# A4. Arboricultural Impact Assessment Technical Note

- 4.1.1 The proposed changes to the scheme design have resulted in additional tree constraints being identified within the proposed updates to the red line boundary. Therefore, the Arboricultural Impact Assessment (AIA) (Appendix 7.3 of Volume 6.3 of the 2018 ES (APP-071)) requires updating. This Addendum Technical Note highlights the amendments to the assessment of trees for removal prior to construction works, trees that require pruning, and trees that require barrier protection during the proposed works, as a result of the proposed design changes.
- 4.1.2 The contents of Appendix 7.3 of Volume 6.3 of the 2018 ES (APP-071) remain valid with the exception of the changes described in this Technical Note below.

## **Trees Protection Plan**

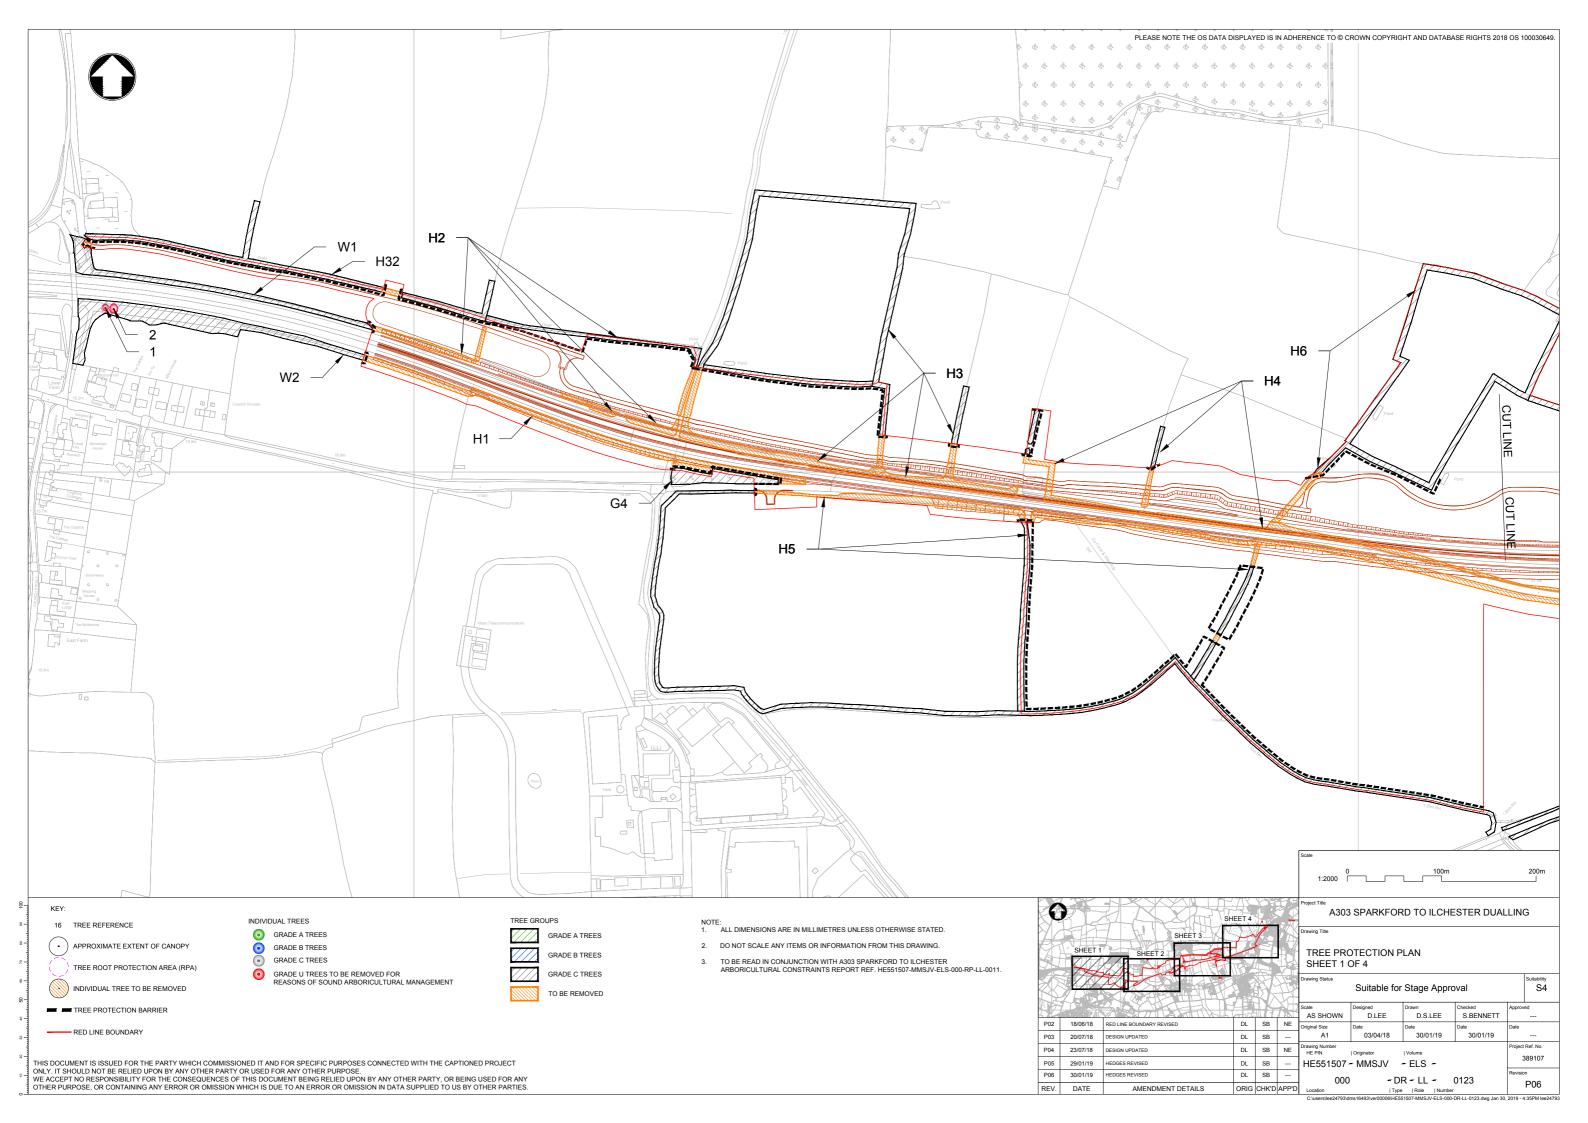
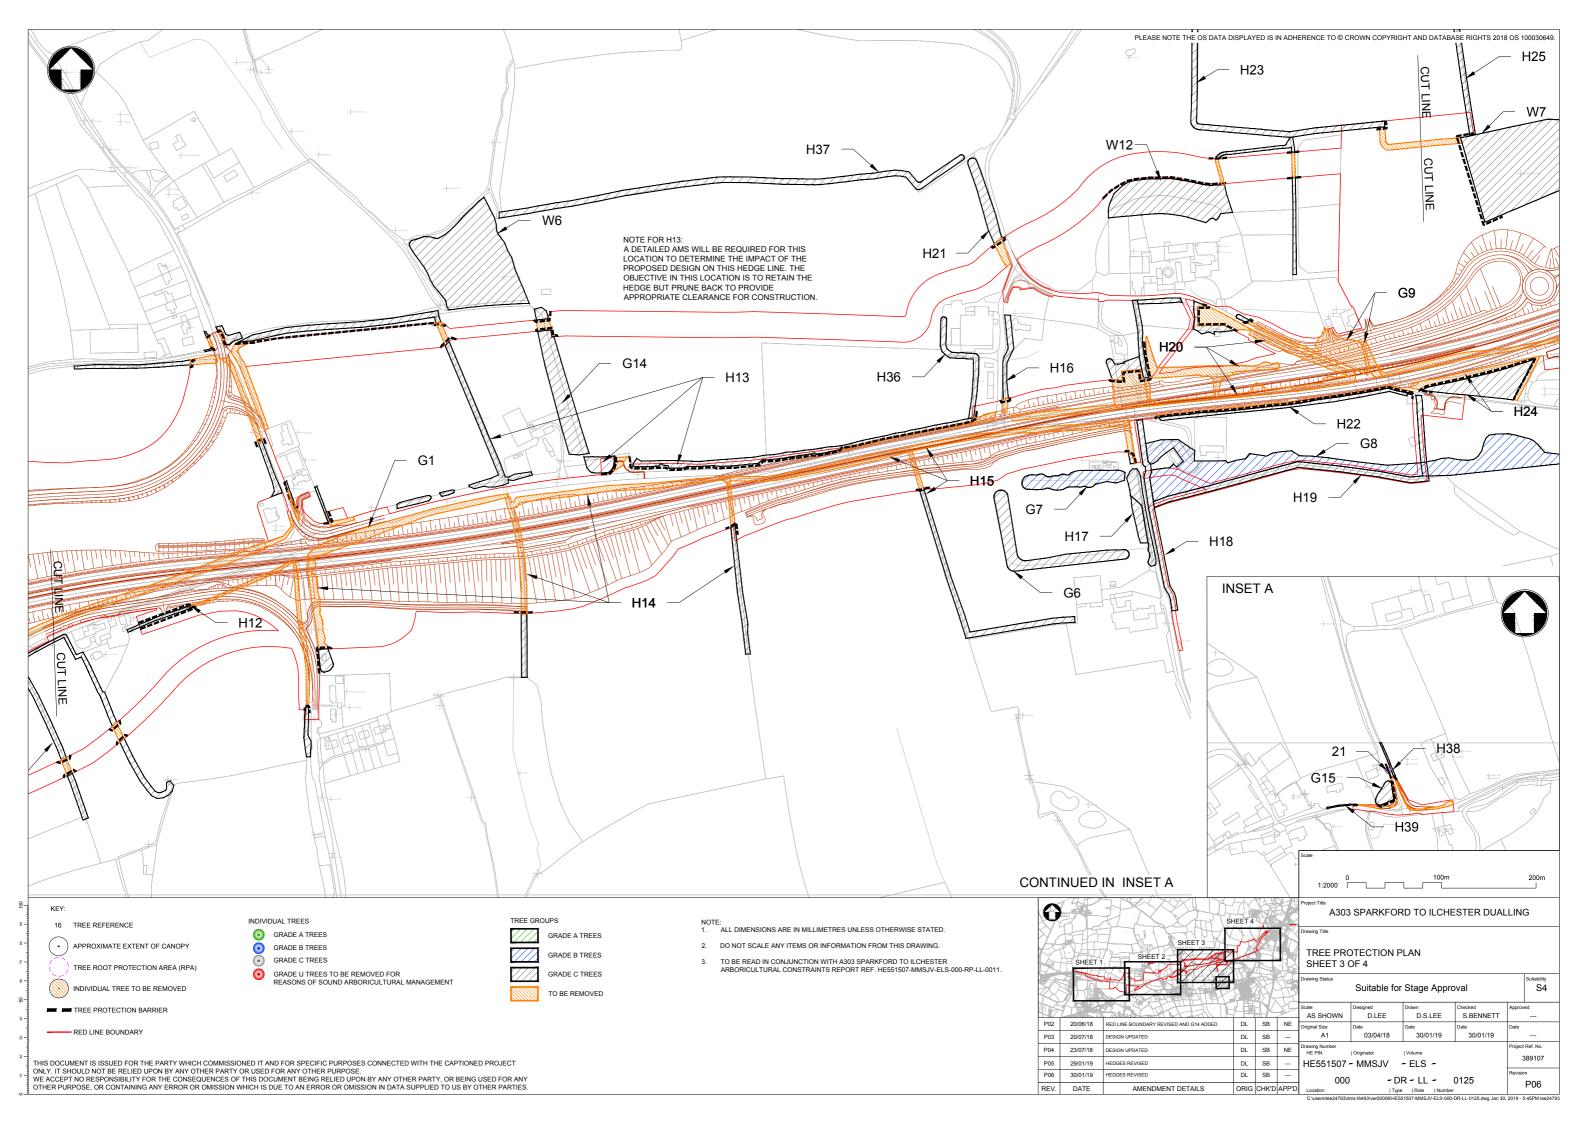
4.1.7 The tree protection plan drawing Sheet 3 of Appendix 7.3 of Volume 6.3 of the 2018 ES (APP-071) has been updated to include the additional trees, as shown below.

## 8.2 Individual Farm Drawings

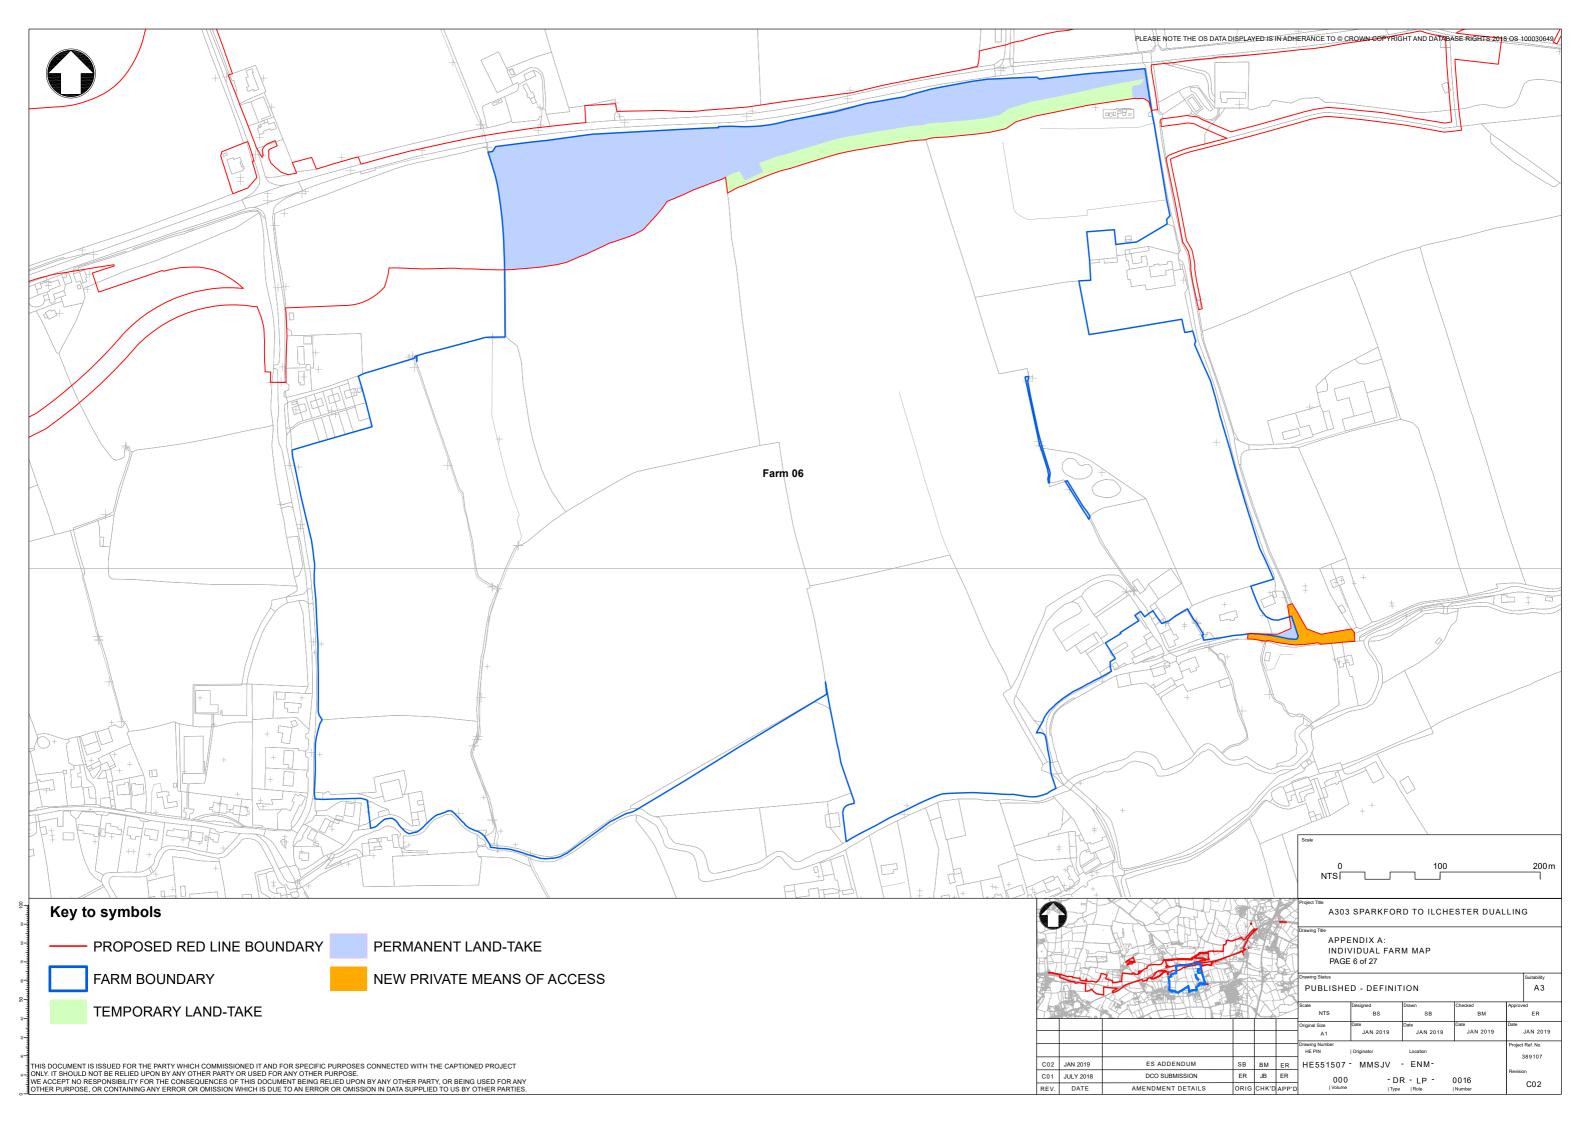
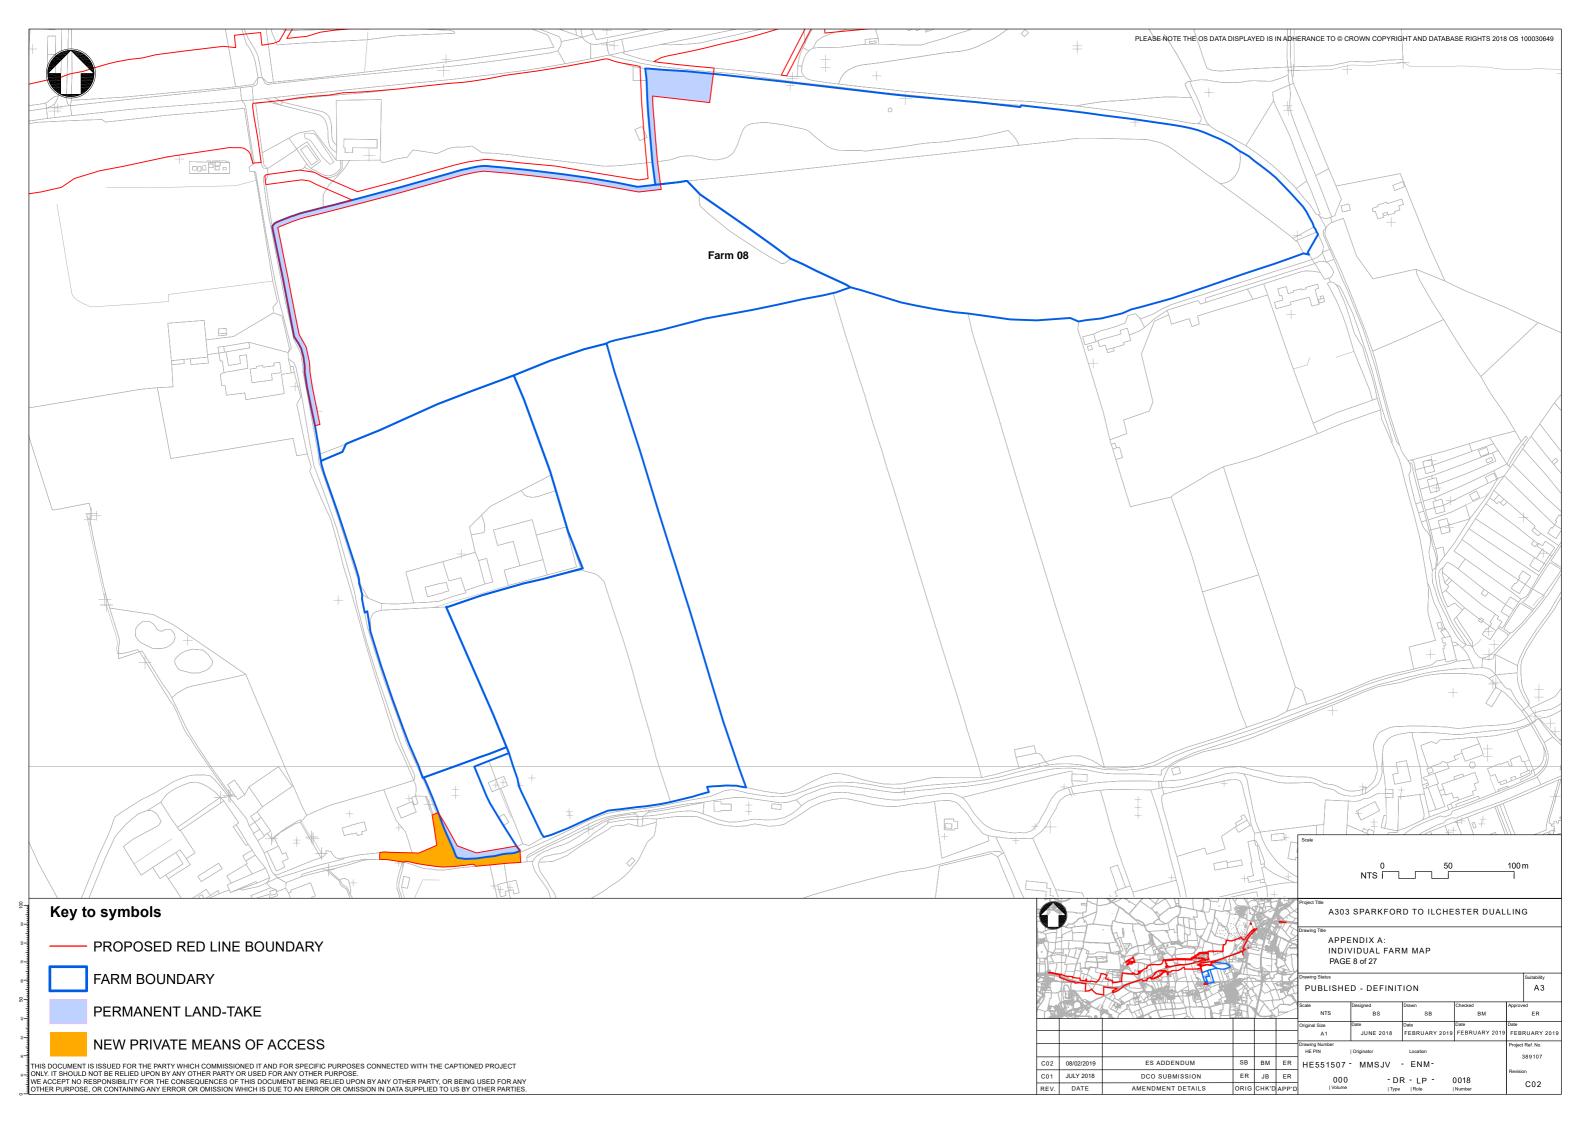
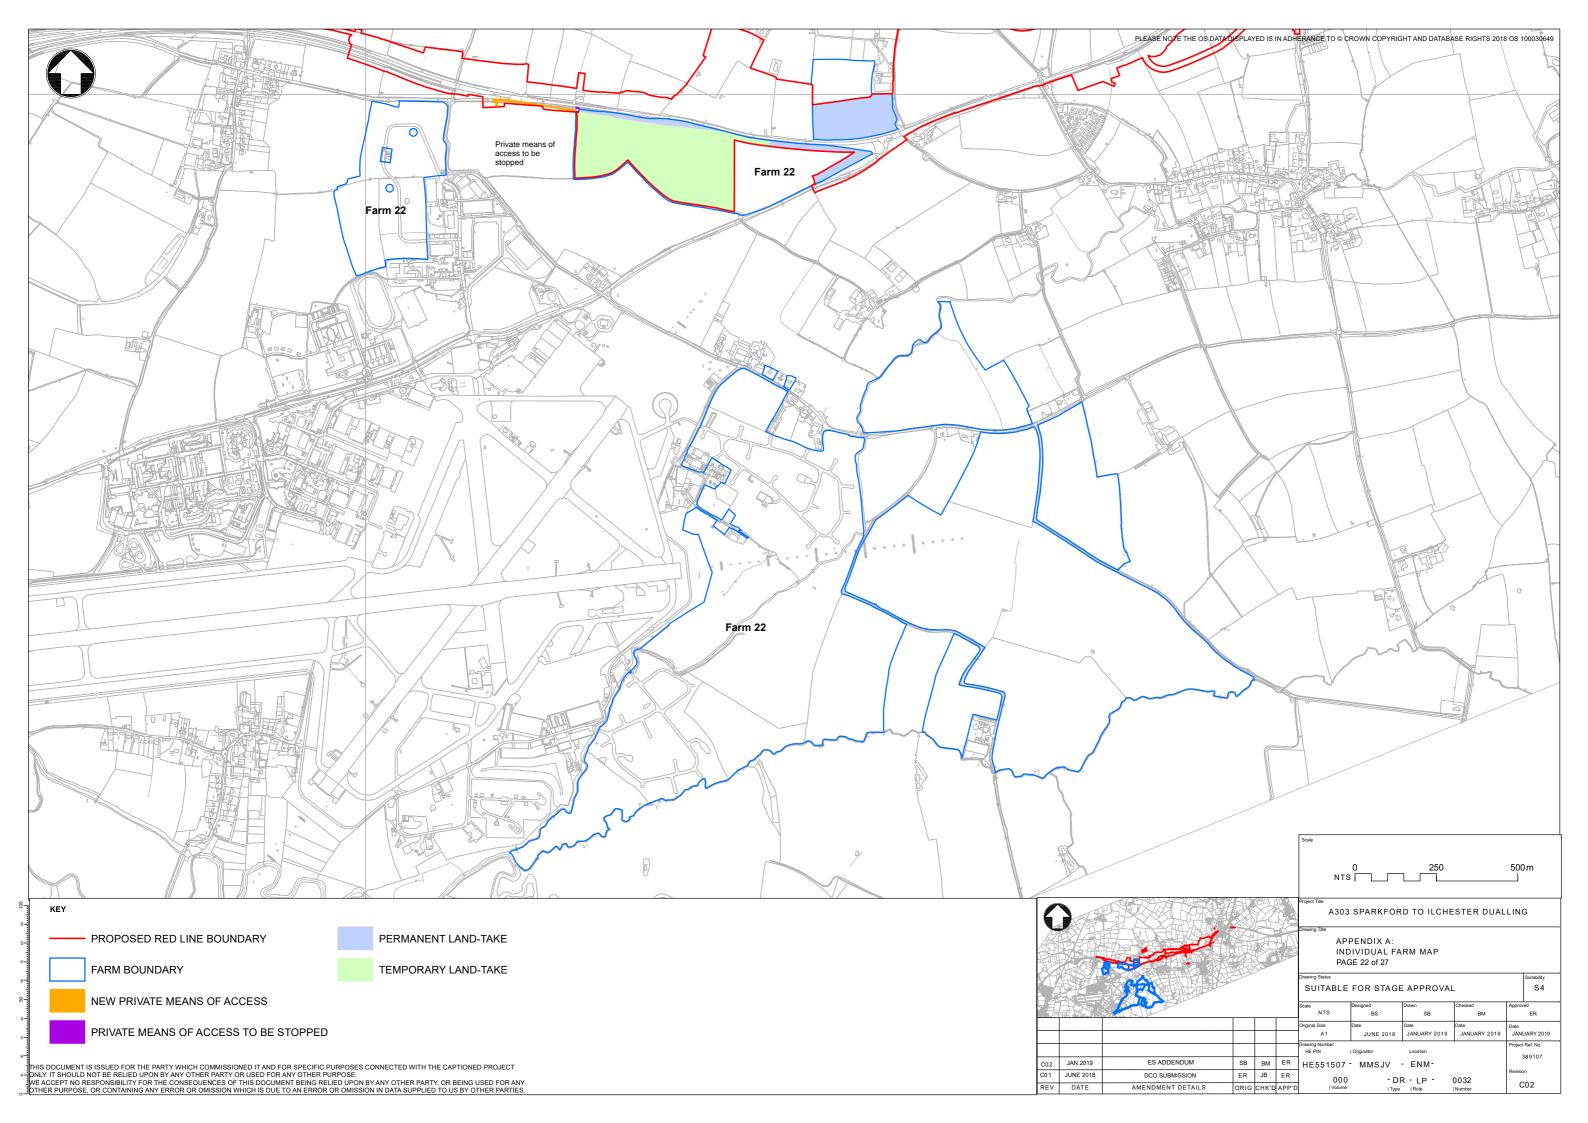
8.2.1 The area of permanent and temporary land take has changed for Farm 06, 08 and 22. The revised drawings can be seen below.
